**STATE OF HAWAII  
DEPARTMENT OF TRANSPORTATION  
HIGHWAYS DIVISION**

**ADDENDUM NO. 3  
for  
KAMEHAMEHA HIGHWAY, KAMANANUI ROAD AND WILIKINA DRIVE  
REHABILITATION  
VICINITY OF WEED CIRCLE TO H-2**

**FEDERAL-AID PROJECT NO. NH-099-1(031)**

ADDENDUM NO. 3  
9/17/20

**TYPICAL SECTION**  
**WILIKINA DRIVE Sta 7+40 TO 31+20**

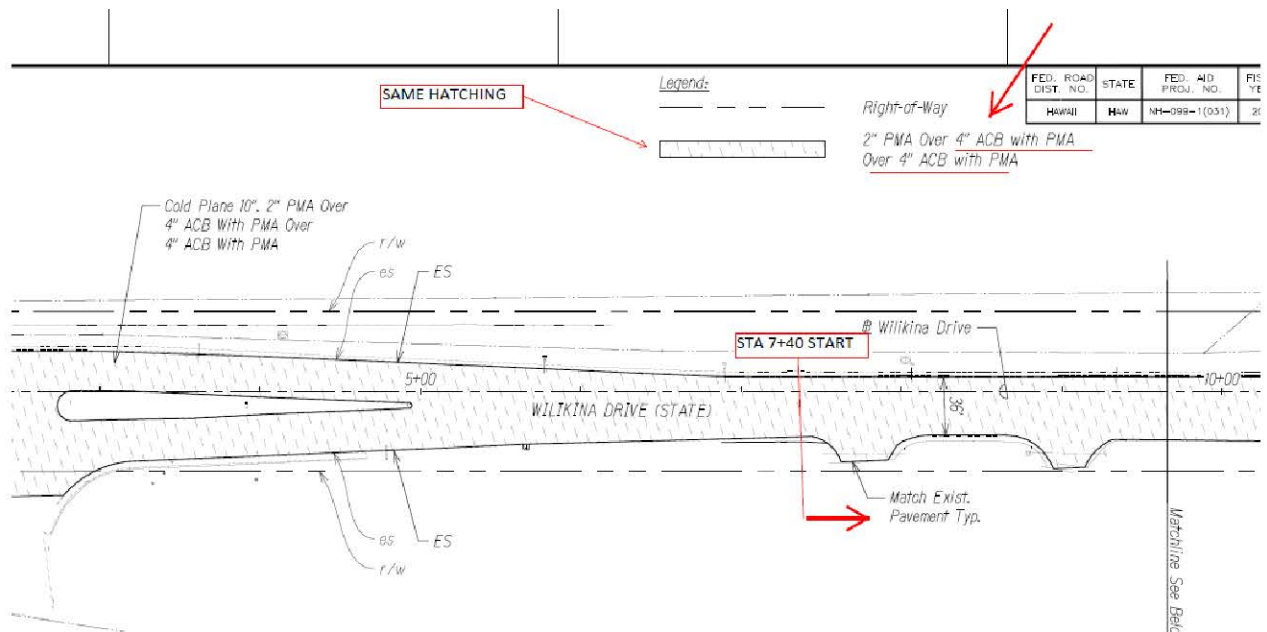
4. See below, Typical Section Sta 7+40 to 31+20 shows ACB without PMA, yet plan sheet C-14 shows same location calling for ACB with PMA, please clarify.

**Typical Section will be revised.**
